Memorandum Department of Planning & Development Services

RE: **P.Z. 07-2017 Chesterfield Valley Motor Sports (17501 N Outer 40 Rd.):**
A request for an amendment to an existing “C8” Planned Commercial District for a 3.0 acre tract of land located north of North Outer 40 Rd west of its intersection with Boone’s Crossing (17U510051).

Re: P.Z. 07-2017 Chesterfield Valley Motor Sports (17501 N Outer 40 Rd) – Ordinance Amendment

PLANNED DISTRICT ORDINANCE
ATTACHMENT B

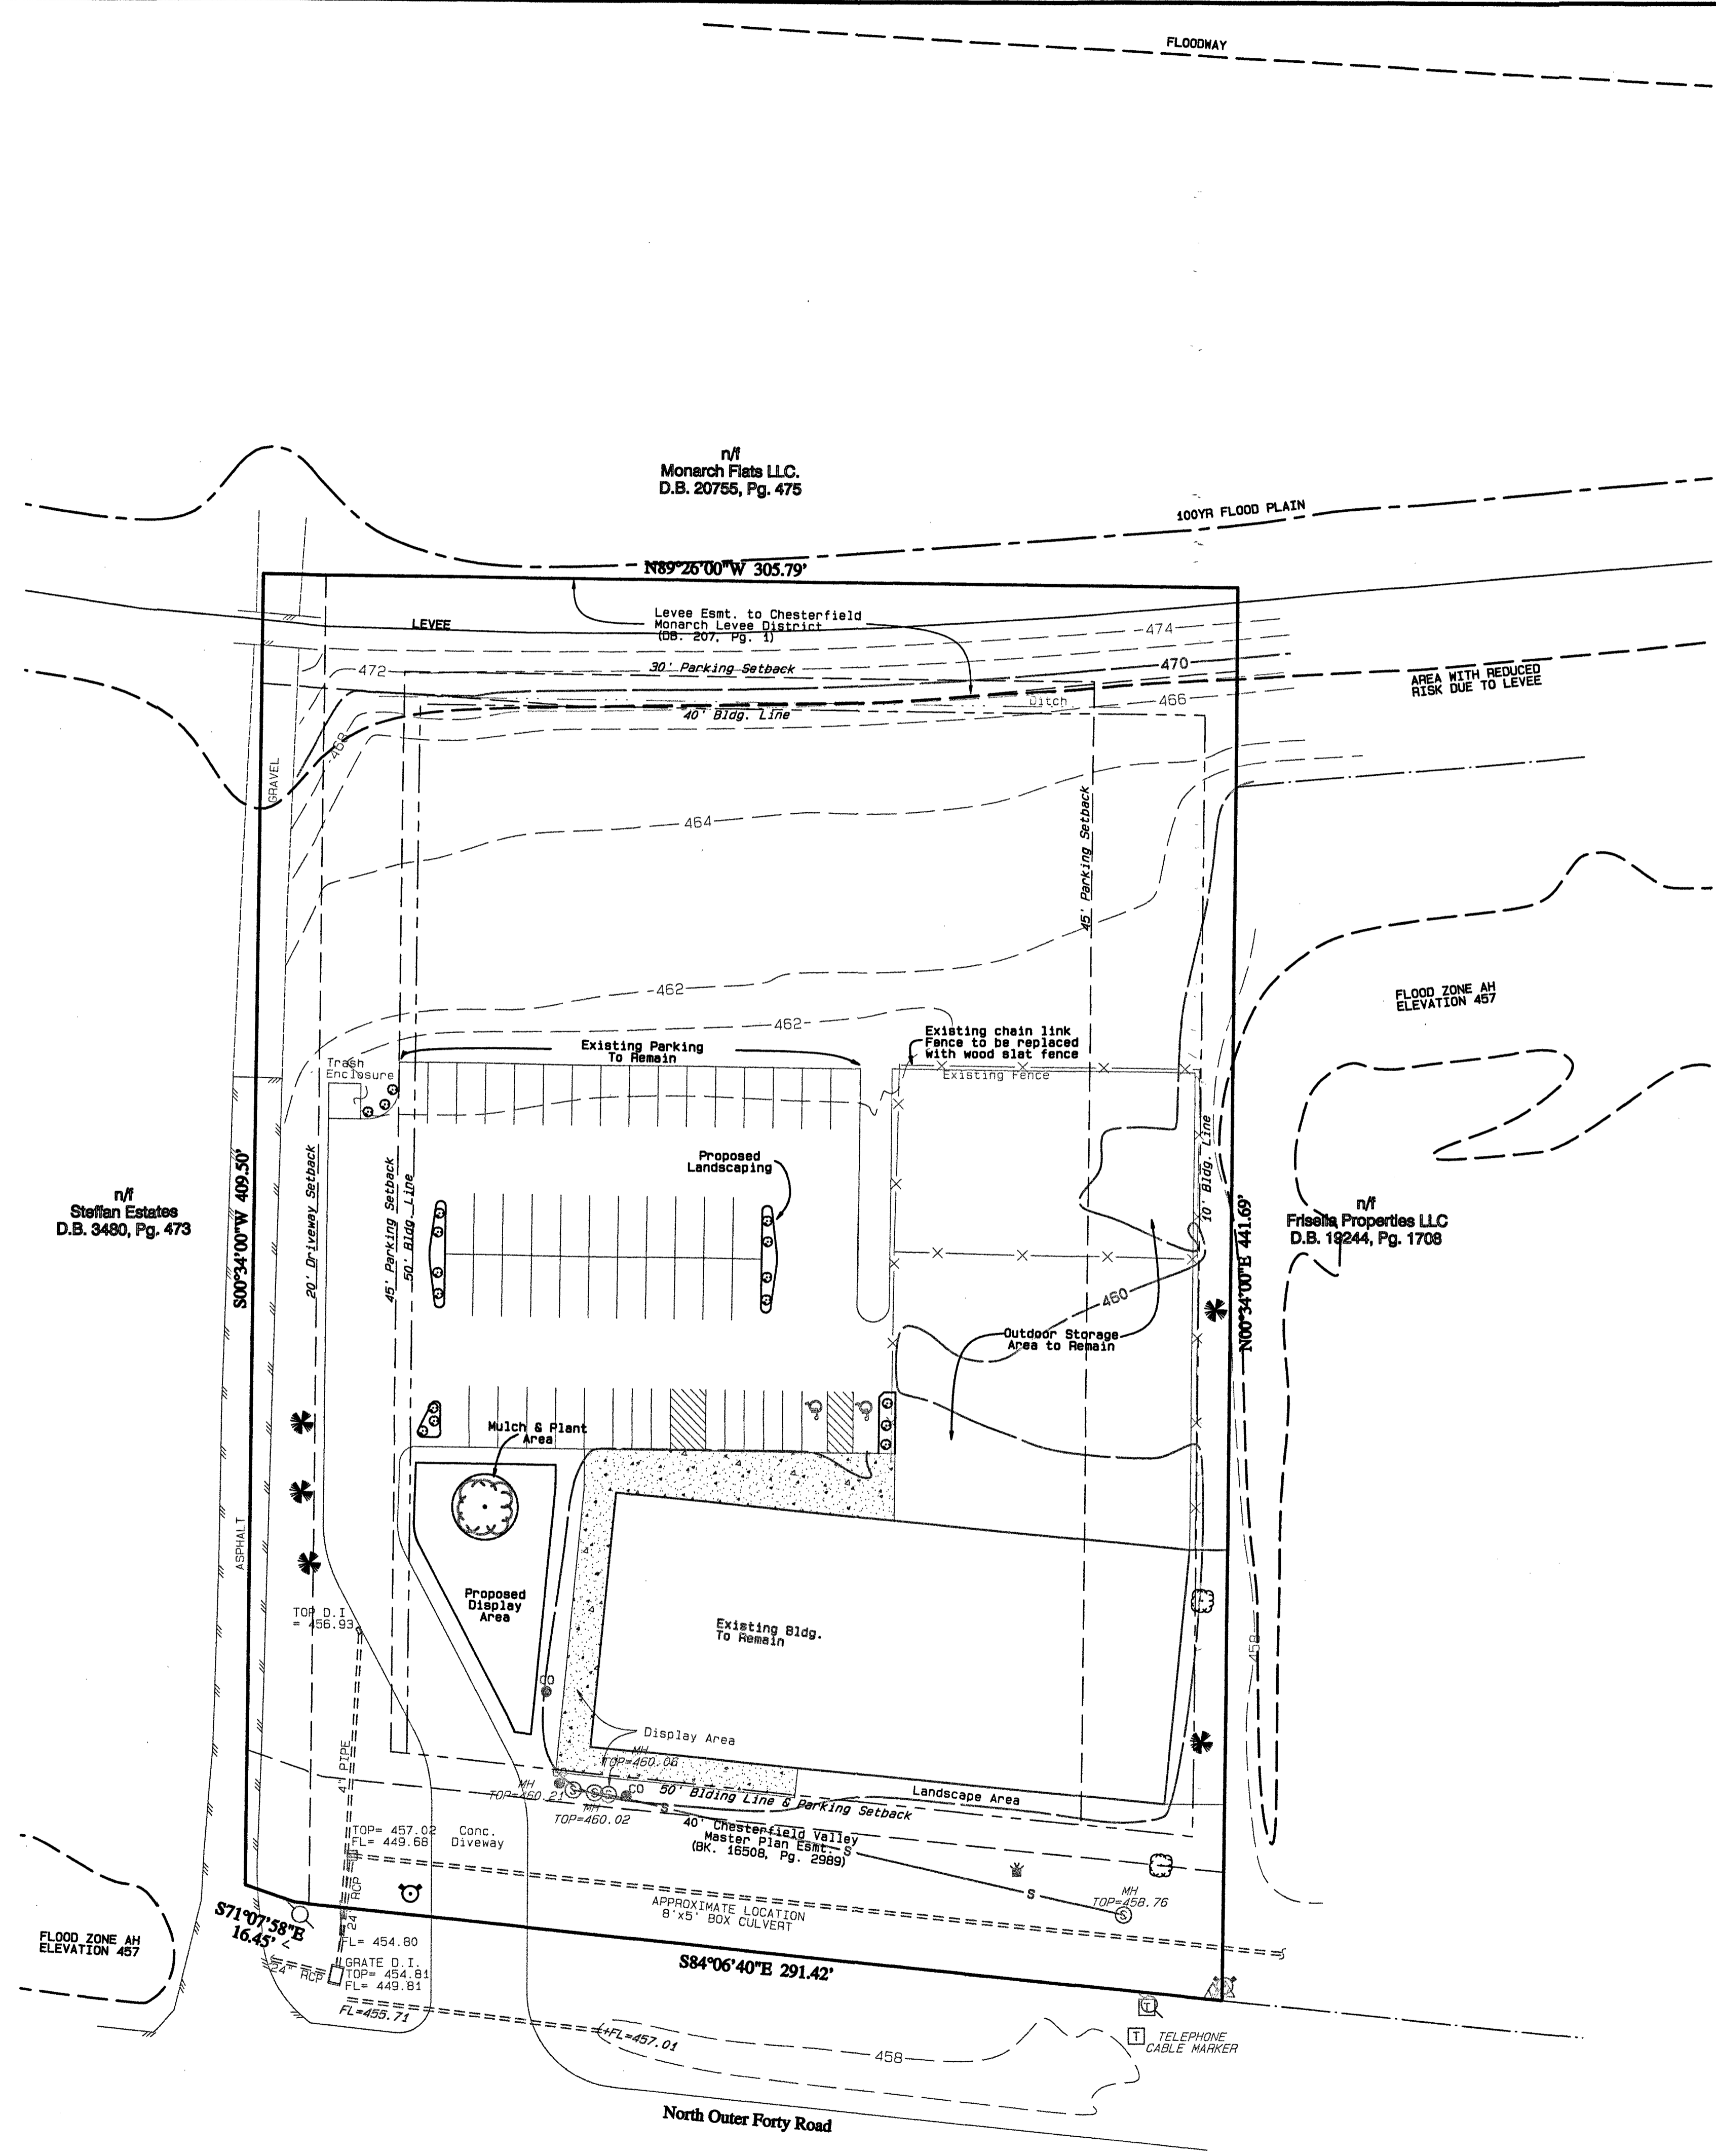
- i. Vehicles will be permitted to be displayed during business hours only.
 - ii. Only **one (1) ~~two (2)~~ vehicles with a footprint no larger than 75 square feet** shall be permitted on the triangular display area west of the building and east of the concrete driveway shown on the Preliminary Plan.

- iii. **For those vehicles displayed within the concrete display area shown on the Preliminary Plan which surrounds the building on a portion of the south and the entire west side, all wheels and support points are to be placed on the concrete.**

CITY OF CHESTERFIELD
ATTACHMENT C

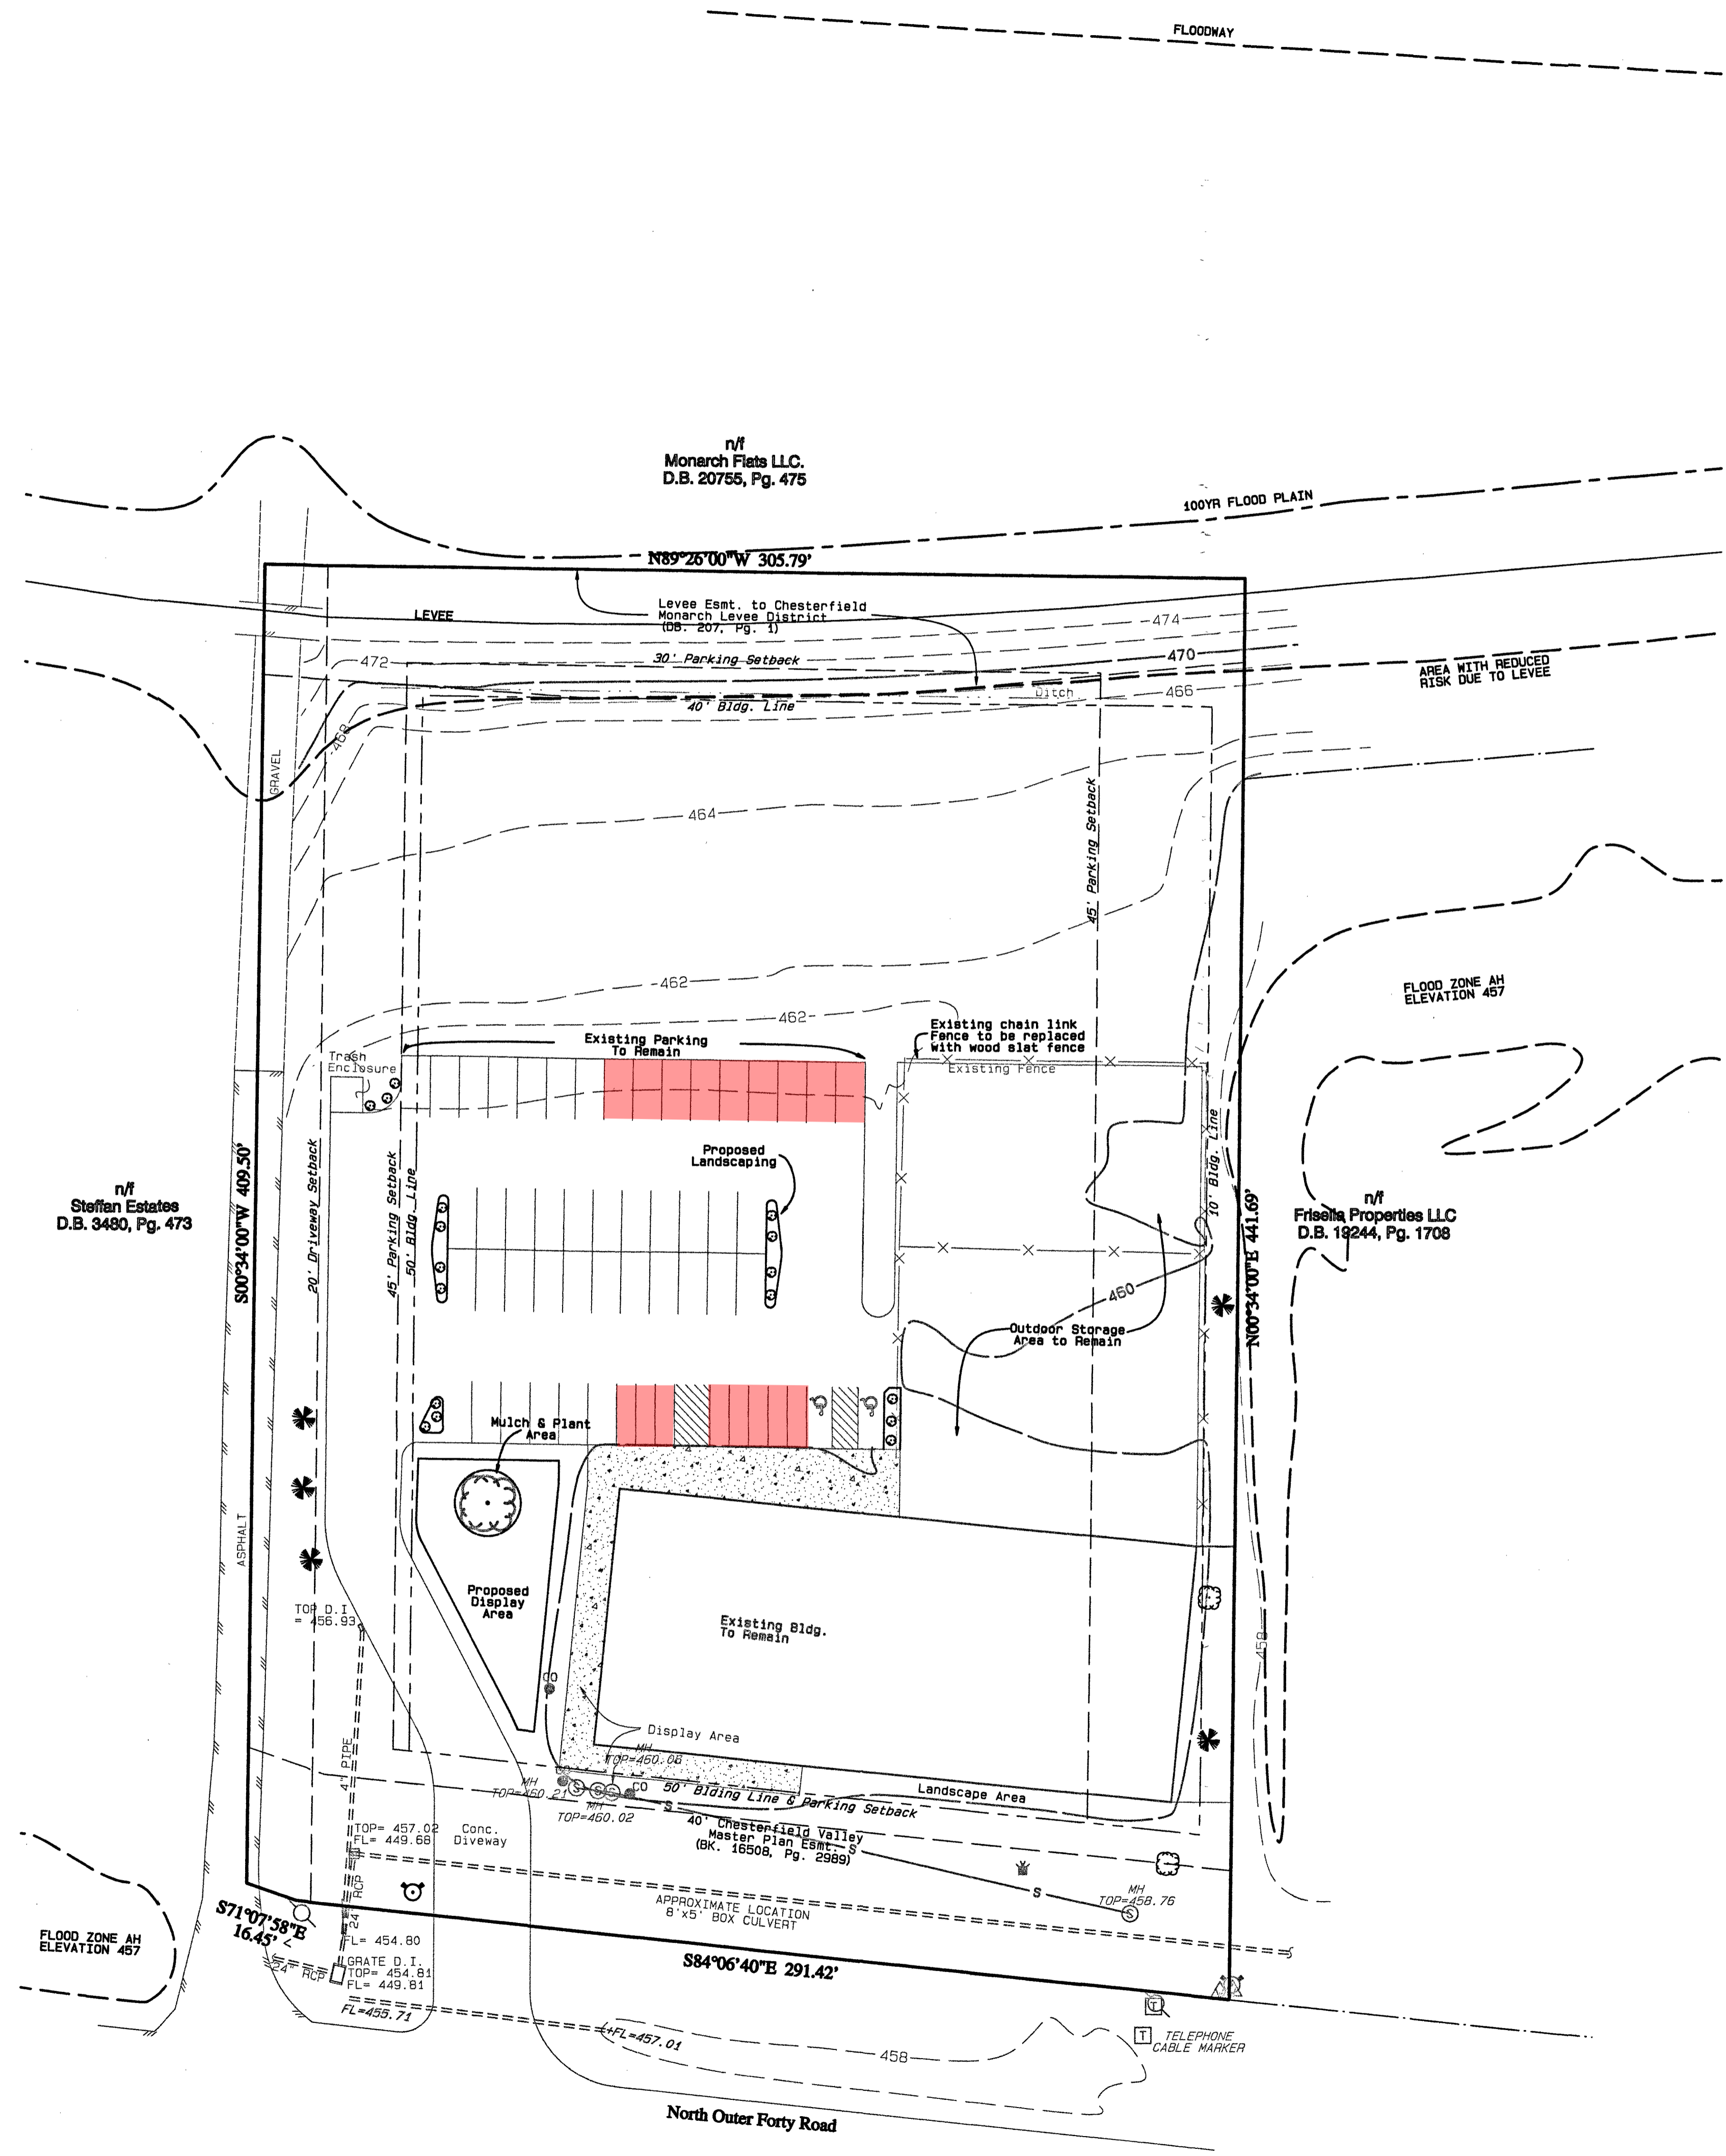
At the meeting on March 22nd, the Committee expressed a desire to see the display vehicles restricted to a specific area to limit visibility of these vehicles from the road. If the Committee wishes to limit this, Staff would recommend limiting the display vehicles to areas shown in Figure 1 below.

- c. If there are parking spaces which exceed the required parking of the site as approved on the Site Development Plan, vehicles for sale and displayed in the parking area are limited to areas blocked from view of North Outer 40 Road by the building.

These include the eight (8) motorcycle parking spaces in the first row of parking (abutting the building), and the nine (9) easternmost parking spaces of the northernmost row of parking as delineated on Attachment C.

All vehicles must remain entirely in the parking spaces delineated on Attachment C to ensure parking aisles remain clear at all times.
